Work Order ID 138473

Item ID: D206-667-107BL Accept ***N900040100*** Setup Start ***NS1***
 Revision ID: Stop ***NS2***
 Item Name: Fwd Crosstube - Mid Height 206L / L1 / L3 / L4, Blue
 Start Date: 10/28/2015 Start Qty: 1.00 ***1*** Cust Item ID:
 Required Date: 10/28/2015 Req'd Qty: 1.00 ***1*** Customer:
 Reference:

DRAWING NO. D206-667-147	TITLE CROSSTUBE ASS'Y (206L MID FWD)	REV. A	DART AEROSPACE LTD ENGINEERING ORDER		D.E.O. NO. D206-667-147-A-1	SHEET NO. SHEET 1 OF 1	SCALE NTS
DRAWN <i>92</i>	CHECKED <i>ADS</i>	MFG. APPR. <i>AB</i>	APPROVED <i>MD</i>		DE APPR. <i>MD</i>		
DATE 11.07.15	DATE 11.07.20	DATE 11.07.21	DATE 11.07.21		DATE 11.07.21

DRAWING NO. D206-667-147	TITLE CROSSTUBE ASS'Y (206L MID FWD)	REV. A	DART AEROSPACE LTD ENGINEERING ORDER	D.E.O. NO. D206-667-147-A-2	SHEET NO. SHEET 1 OF 1	SCALE NTS
DRAWN AJS	CHECKED	MFG. APPR.	APPROVED	DE APPR.		
DATE 12.08.02	DATE 12.08.02	DATE 12.08.02	DATE 12.08.02	DATE 12.08.02	DATE 12.08.02

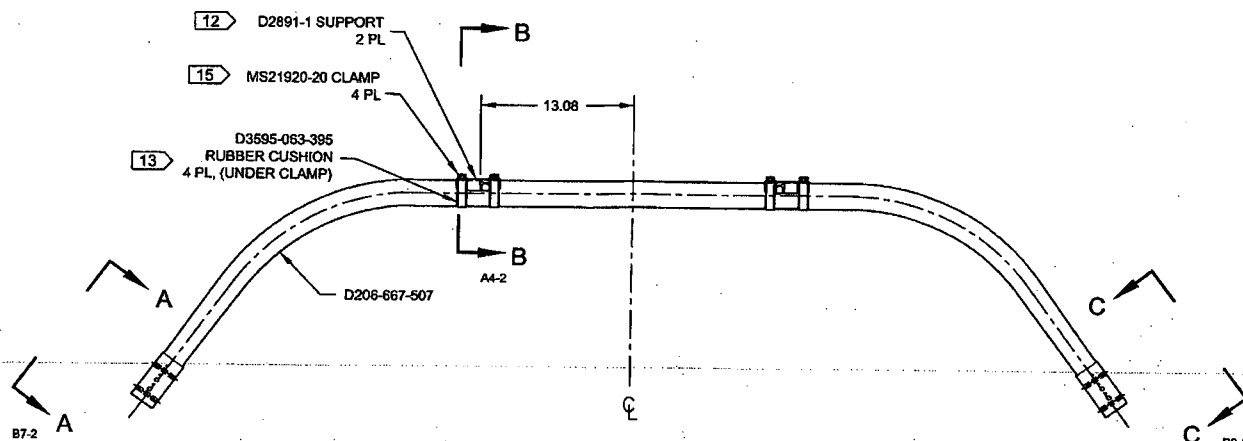
PURPOSE:

REPLACE MAGNOBOND WITH PROSEAL.

NOTE 12 & 15, SHEET 1 IS AMENDED AS FOLLOWS:

Item	Qty -147	Part Number	Description
9	A/R	PROSEAL 890 B-2	SEALANT, AMS-S-8802 CLASS B-2

- 12) TO INSTALL D2891-1 SUPPORT: ABRASE MATING SURFACE OF SUPPORT AND CROSSTUBE WITH 180-GRIT SANDPAPER AND REMOVE RESIDUE WITH MEK (OR EQUIVALENT). APPLY A 0.04" TO 0.07" THICK LAYER OF PROSEAL 890 CLASS B-2 (OR AMS-S-8802 CLASS B-2) SEALANT TO MATING SURFACE OF SUPPORT.
- 15) TORQUE CLAMPS 80 TO 100 IN-LB. ENSURE AT LEAST 1.5 THREADS SHOWING IN SAFETY AND THAT NUT HAS NOT BOTTOMED-OUT AFTER TORQUING. **PRIOR TO PACKAGING, RE-CHECK TORQUE ON CLAMPS AFTER PROSEAL 890 SEALANT HAS CURED FOR 72 HOURS.**

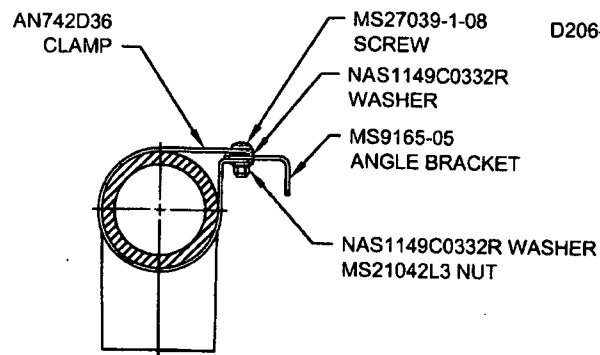
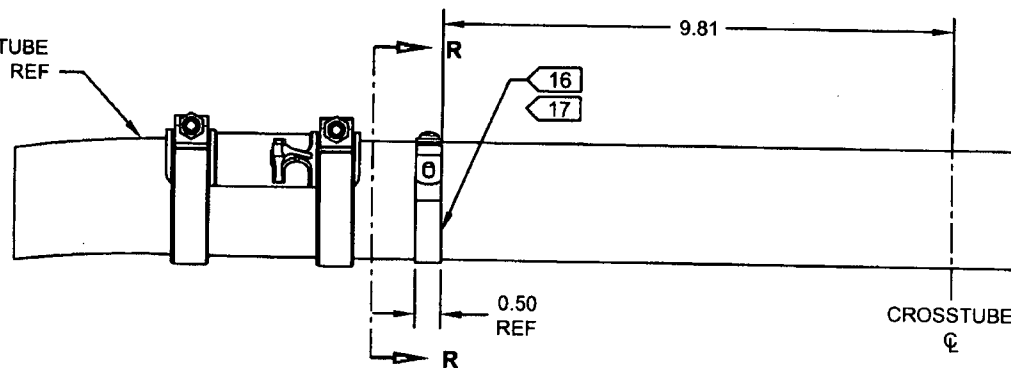
PURPOSE:

ADD ELECTRICAL GROUNDING STRAP

ITEM	QTY -147	PART NUMBER	DESCRIPTION
1	X	D206-667-147	CROSSTUBE ASSEMBLY (206L MID FWD)
10	2	AN742D36	CLAMP
11	2	MS9165-05	ANGLE BRACKET
12	2	MS21042L3	NUT (OR MS21042-3)
13	2	MS27039-1-08	SCREW
14	4	NAS1149C0332R	WASHER (OR AN960C10L)

- 16) MASK AREA UNDER CLAMP PRIOR TO PAINTING
- 17) SEAL EDGES WHERE AN742D36 CLAMP MEETS WITH THE CROSSTUBE USING SIKAFLEX-241/-291 OR MIL-S-8802 CLASS B2 OR PROSEAL 890 SEALANT
- 18) PERFORM RESISTANCE CHECK TO ENSURE MAX RESISTANCE IS 10 MILLIOHMS

DETAIL P
BONDING STRAP INSTALLATION 2 PL
